Green Text = The Engineer of Record answers on the El Paso County Comments Rev. 0 for Variance of Use project

1185 N Curtis Rd, Colorado Springs, CO 80930

PROJECT NAME:
**VARIANCE
OF LAND USE**

SHEET NUMBER:
S-1

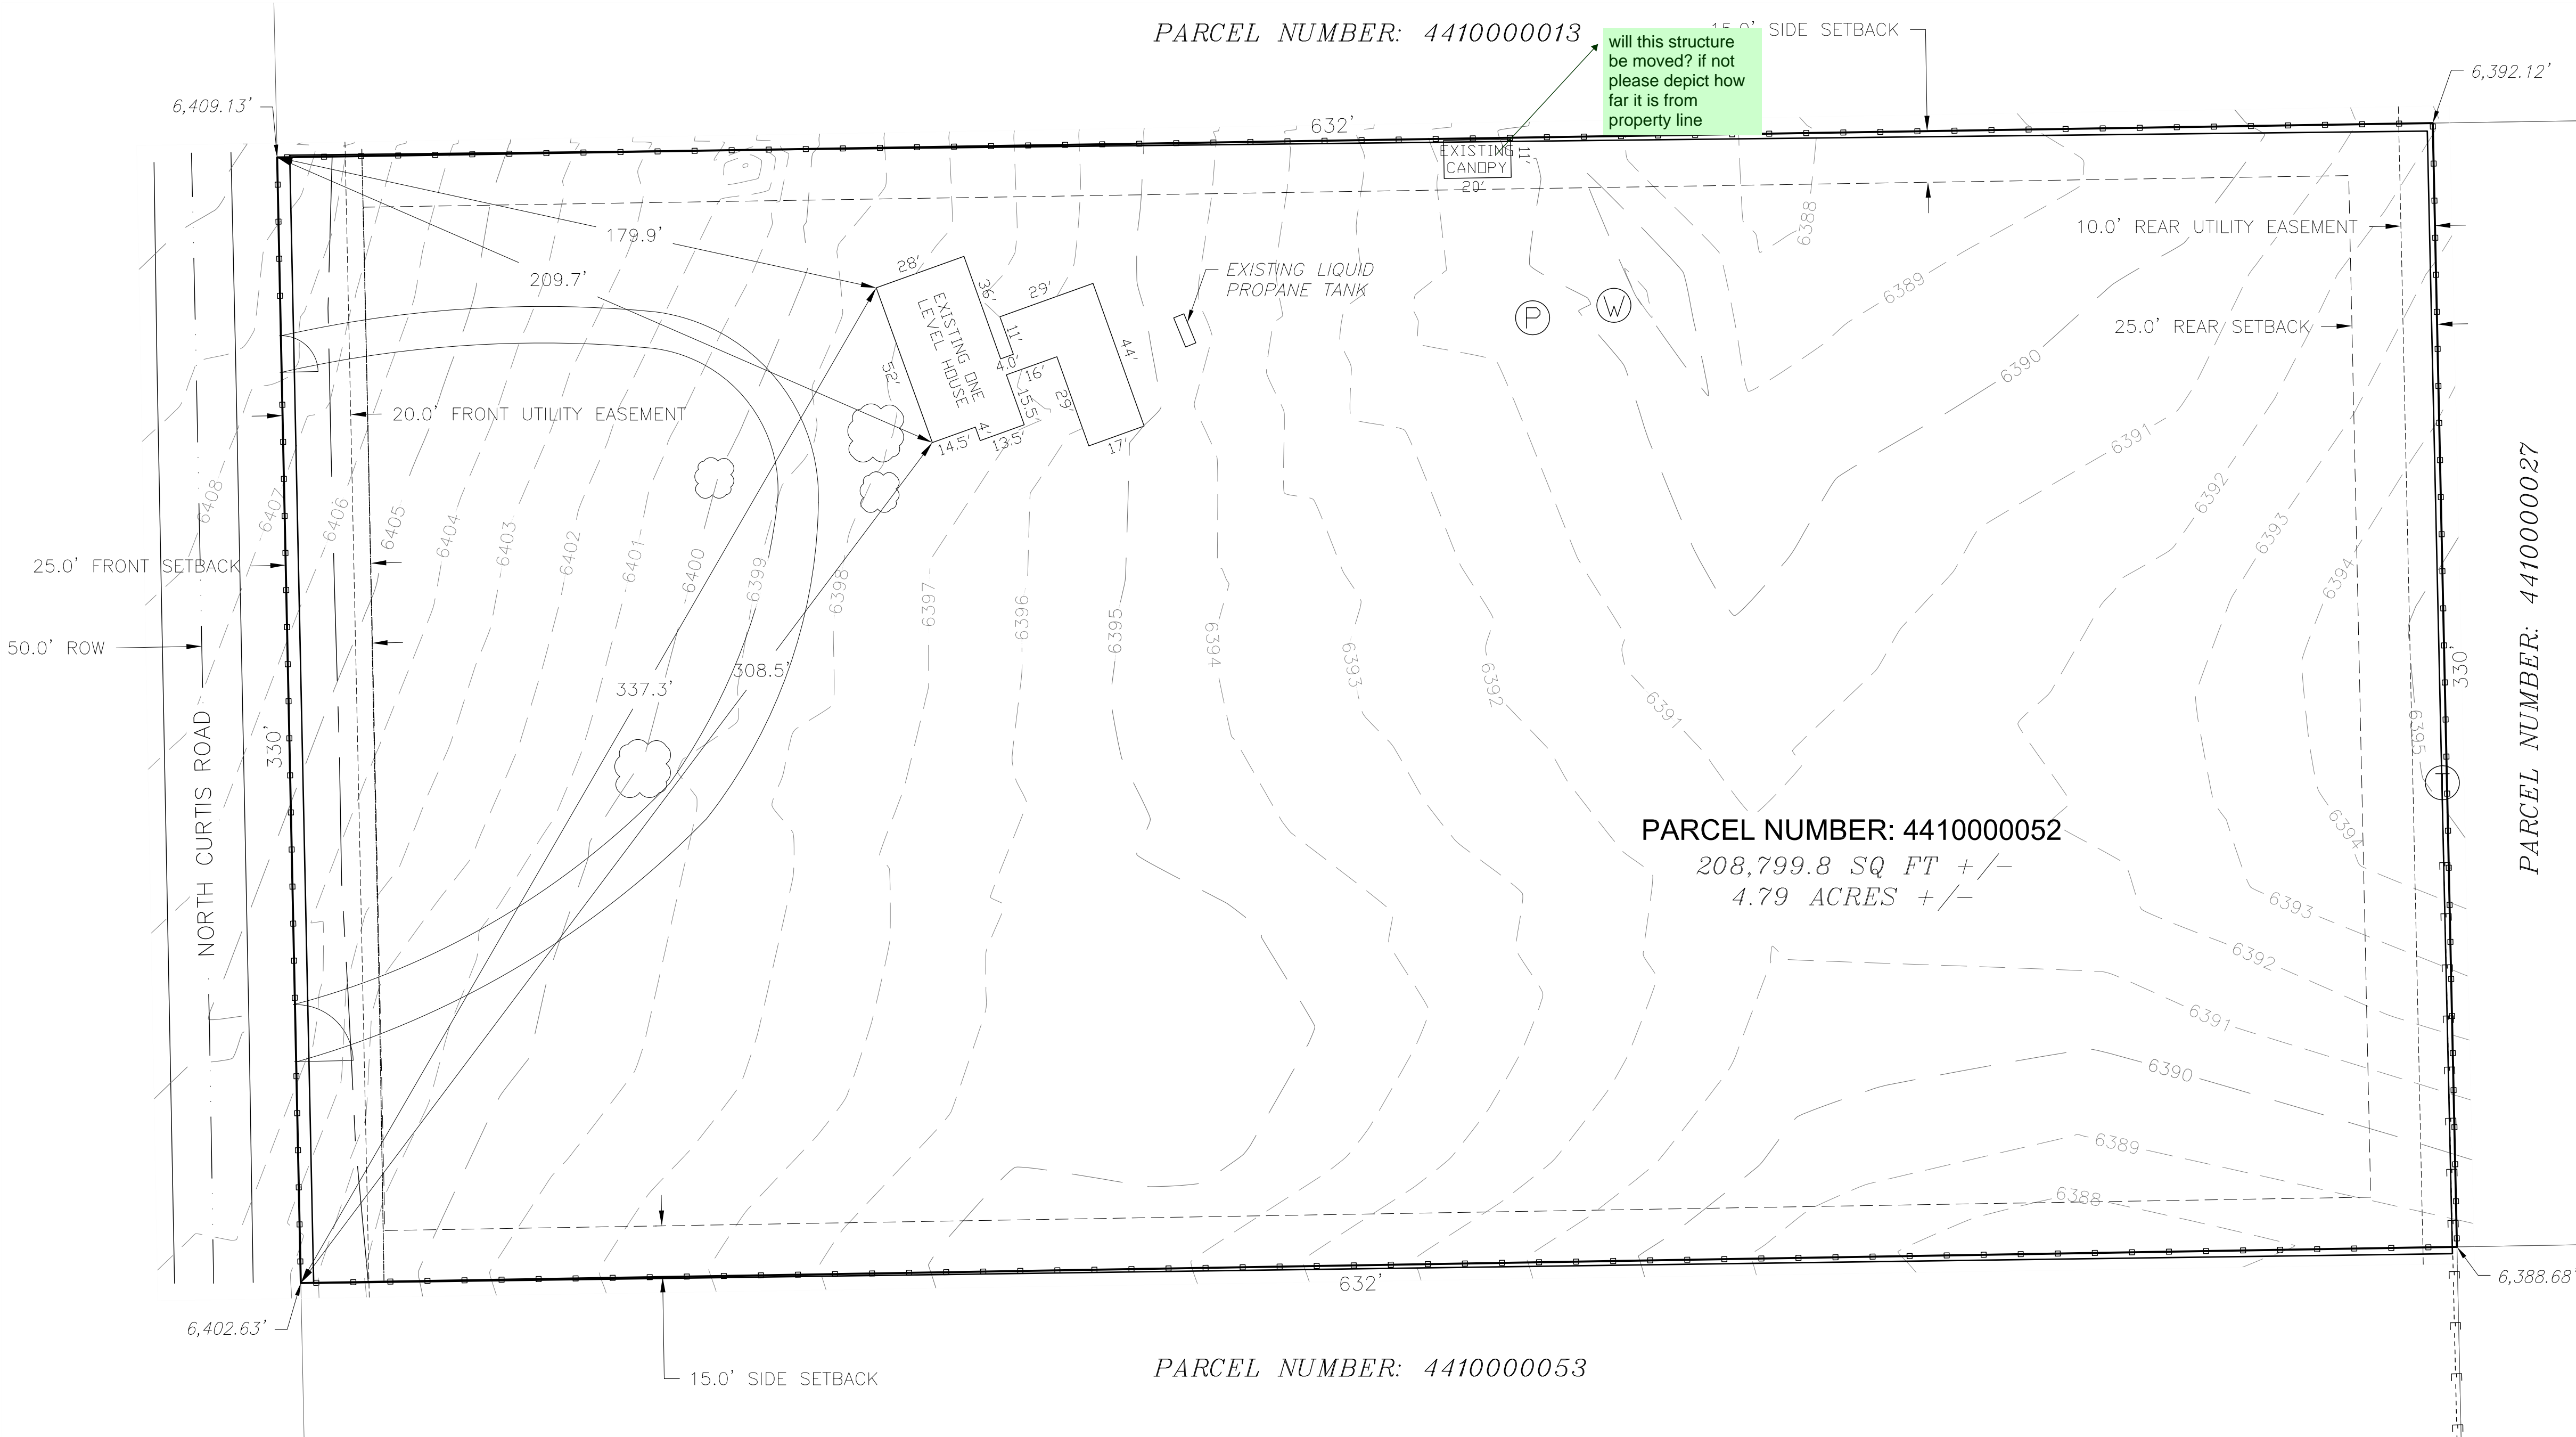
UNRESOLVED:
Please include:

Location of all no-build areas, floodplain(s), and drainage facilities
Location and screening of all dumpster(s) and loading dock areas

SHEET NUMBER:
S-2

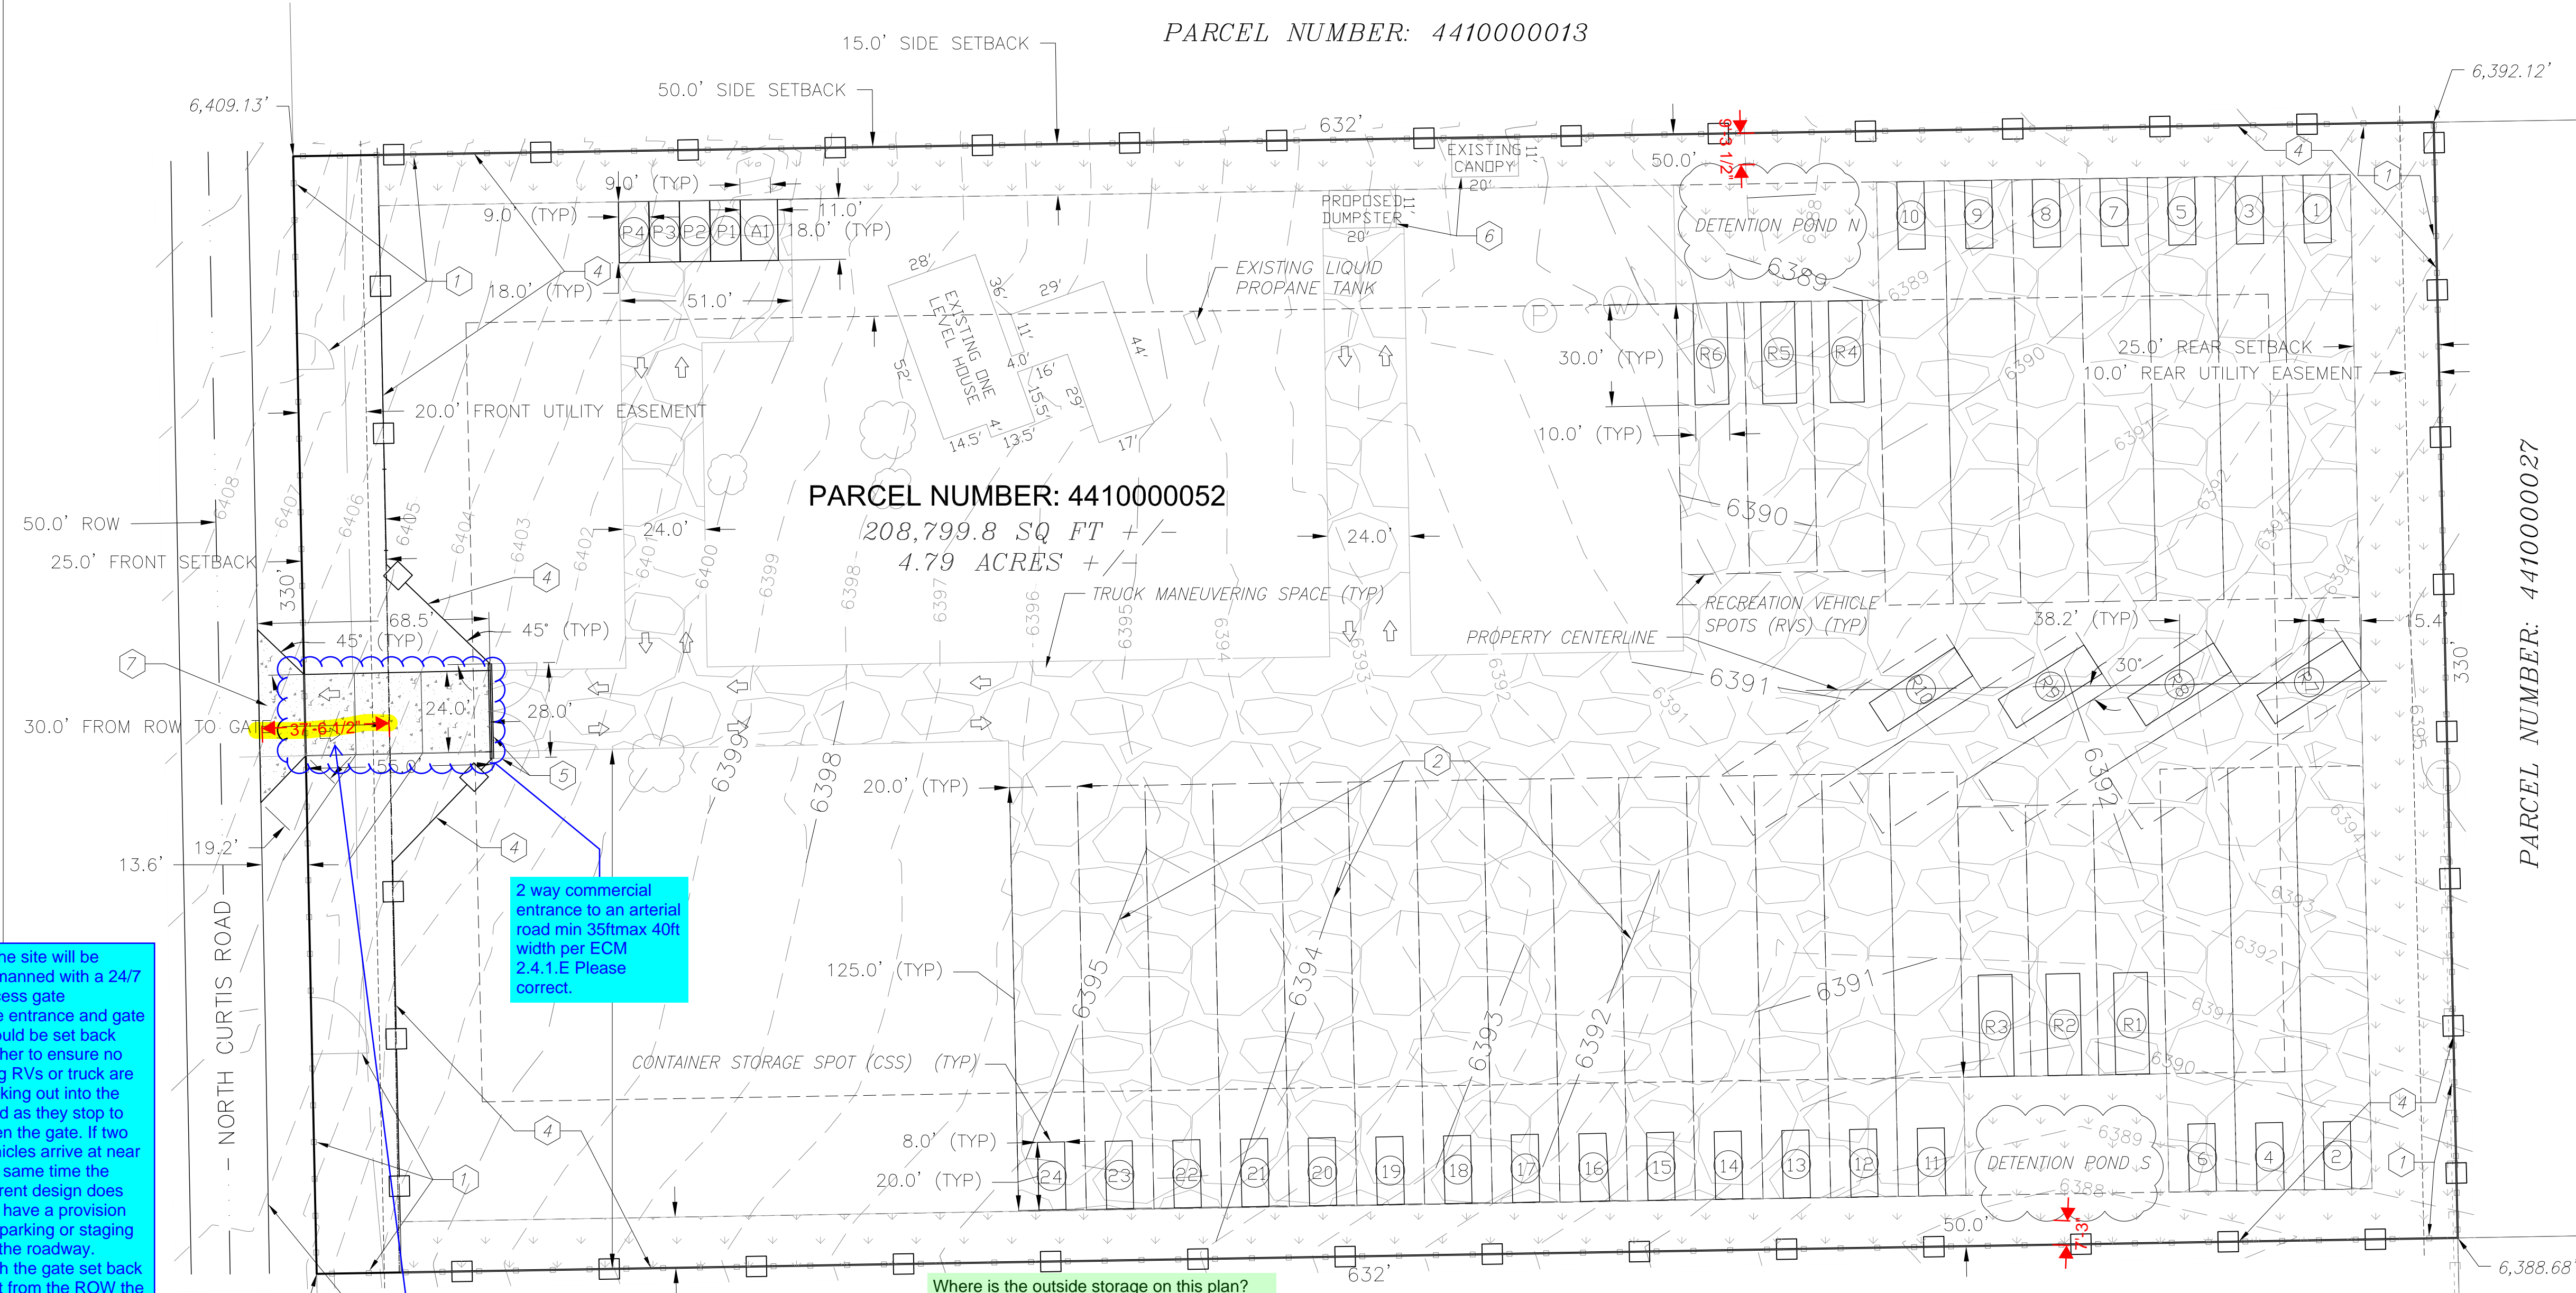
Is the site will be unmaned with a 24/7 access gate
The entrance and gate should be set back further to ensure no long RVs or truck are sticking out into the road as they stop to open the gate. If two vehicles arrive at near the same time the current design does not have a provision for parking or staging off the roadway.
With the gate set back 30ft from the ROW the longest vehicle could be ~37ft or it stick out into the ROW.

2 way commercial entrance to an arterial road min 35ftmax 40ft width per ECM 2.4.1.E Please correct.

Call out entrance surface material type for first 50ft either asphalt mat or concrete

Where is the outside storage on this plan?

Please provide 1 bicycle space Section 6.2.5.F.1

Note the site plan for the Site Dev. Plan approval will be limited as to the number of RV and container storage depicted. If the RV and container storage were to increase the site plan would need to be updated. Additional Road Impact fees would also be applicable. The current provision and density for RV and container storage over the planned ~2ac is very low compared against the capacity with most typical RV storage businesses and lots.

Ensure the planned grading plan and detention pond layout will be functional. The ponds will need proper grading, spilldown areas and proper outlets. With the vehicle and container storage pads directly around the detention ponds this may not be feasible. The ponds may also need to be set back further from the property line to allow for a property outlet structure so no concentrated flow enter the adjacent property. Detailed GEC plan and drainage report will need to be provided with the SDP submittal.

4 VISUAL SCREENING

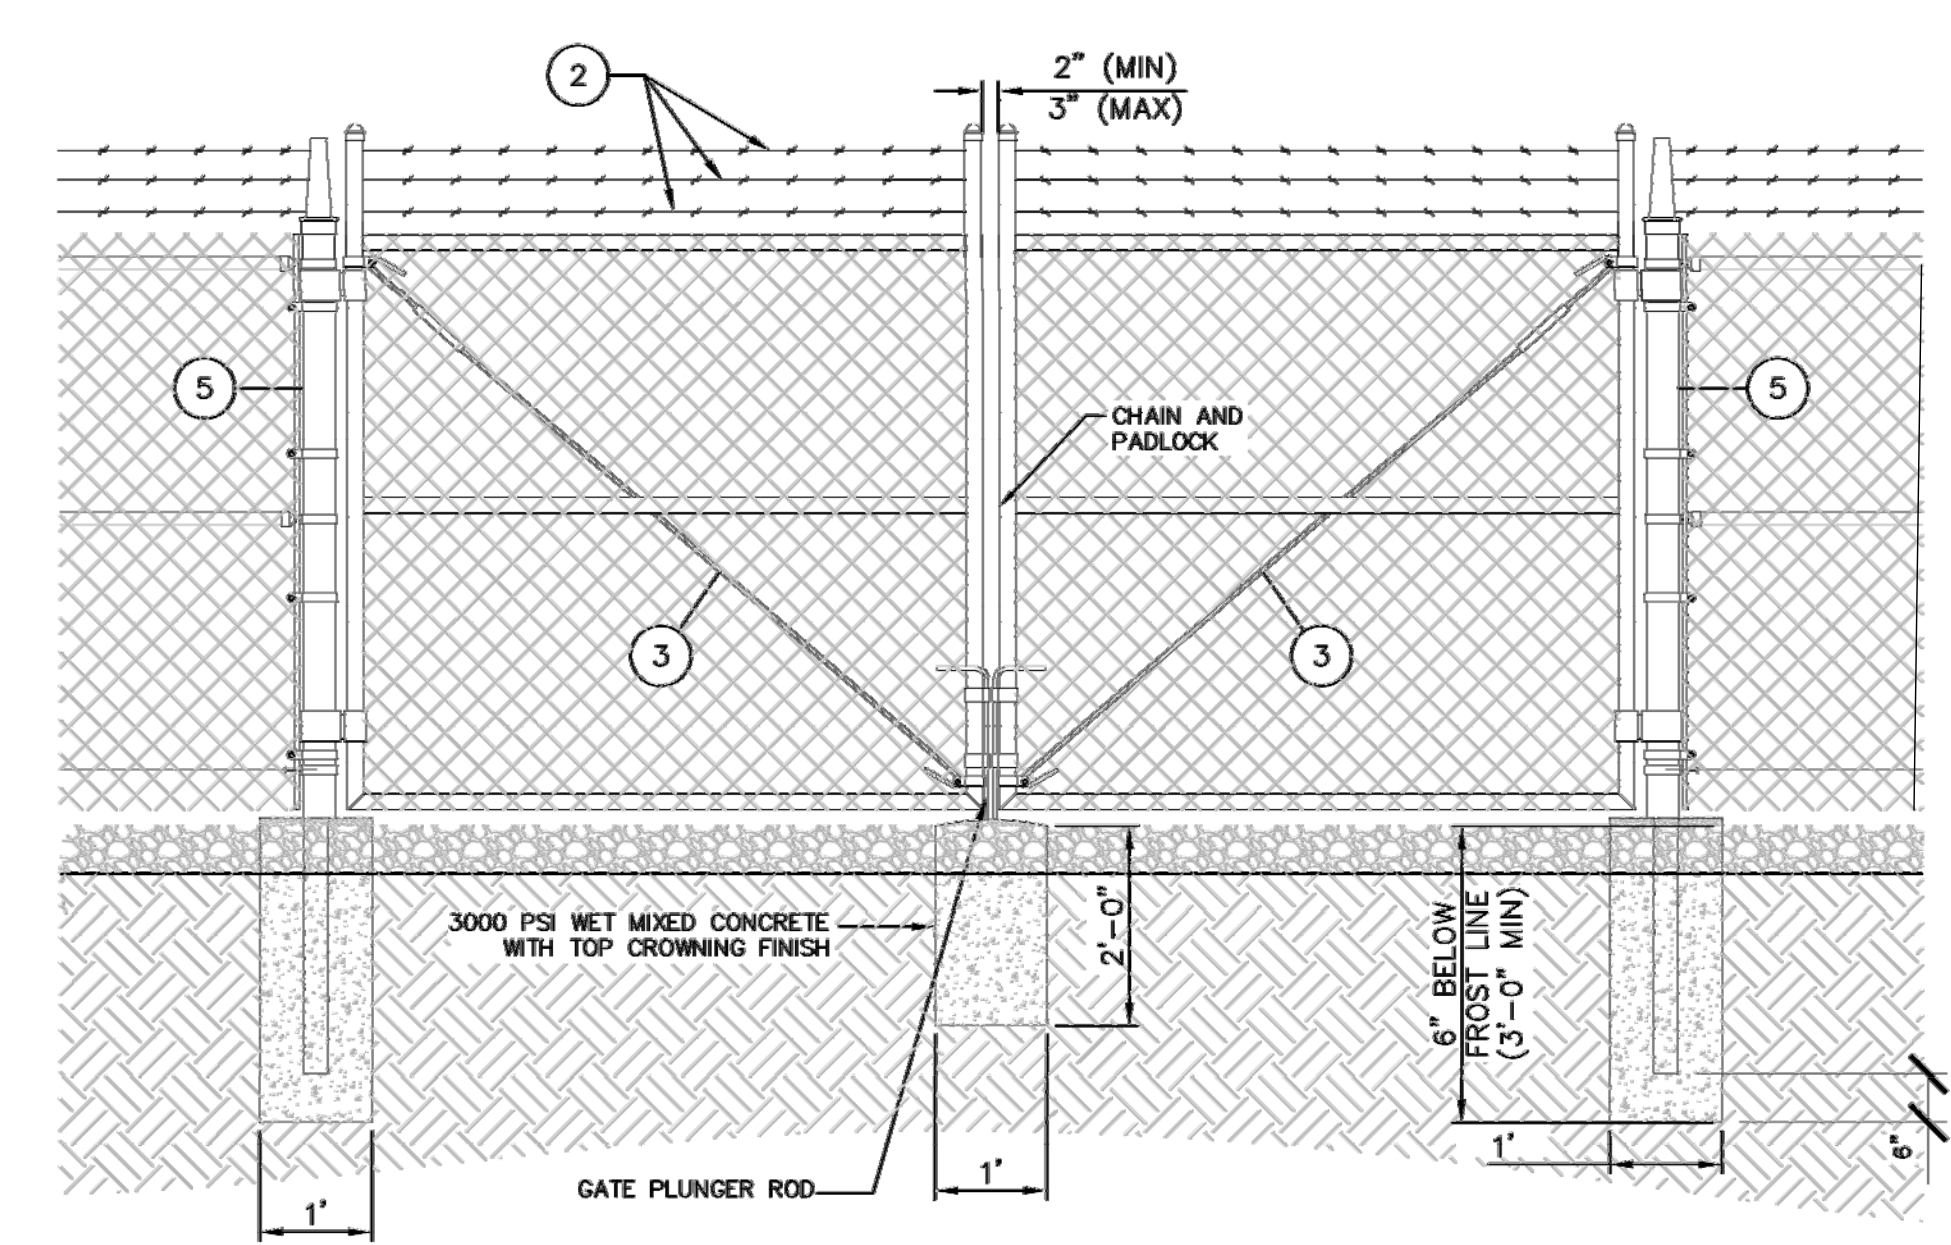
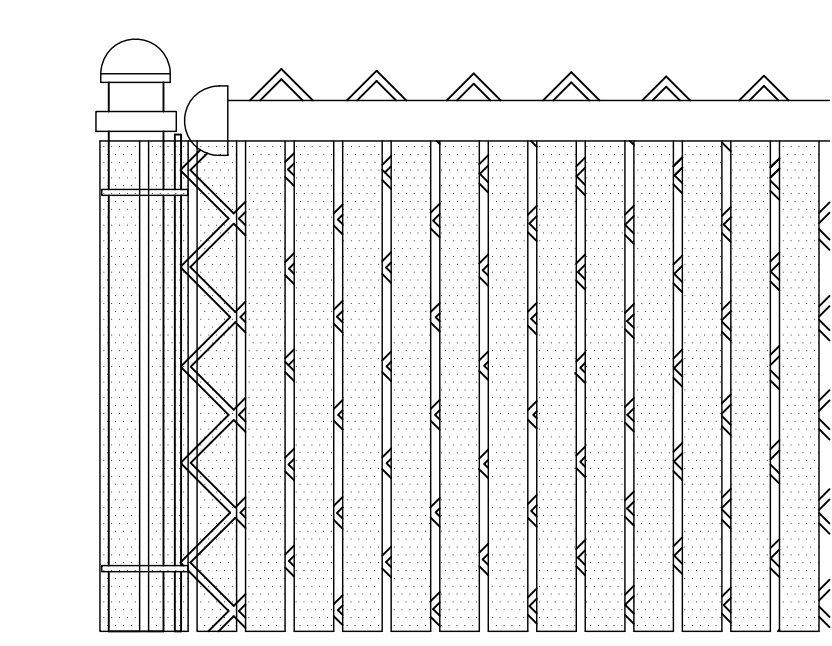
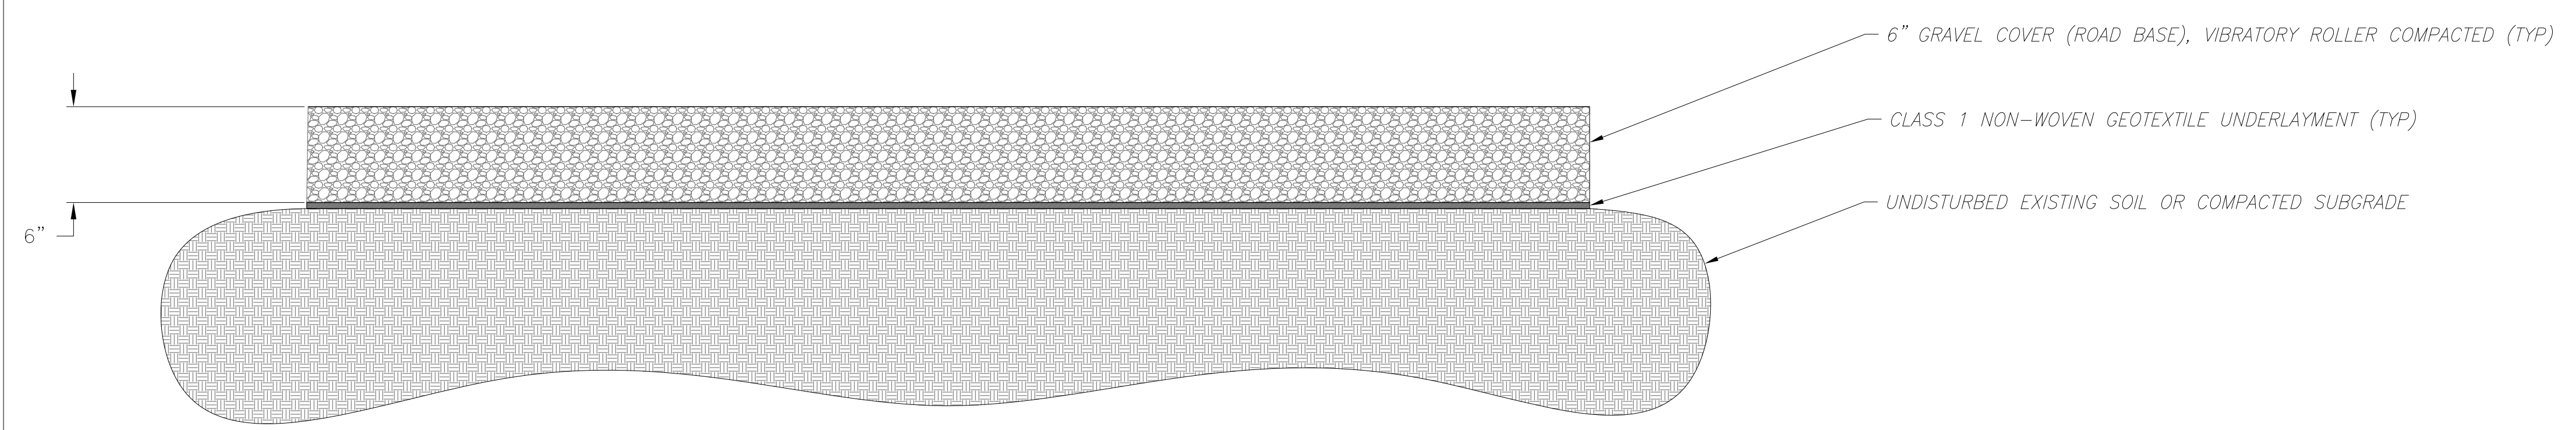
Fence screening material?
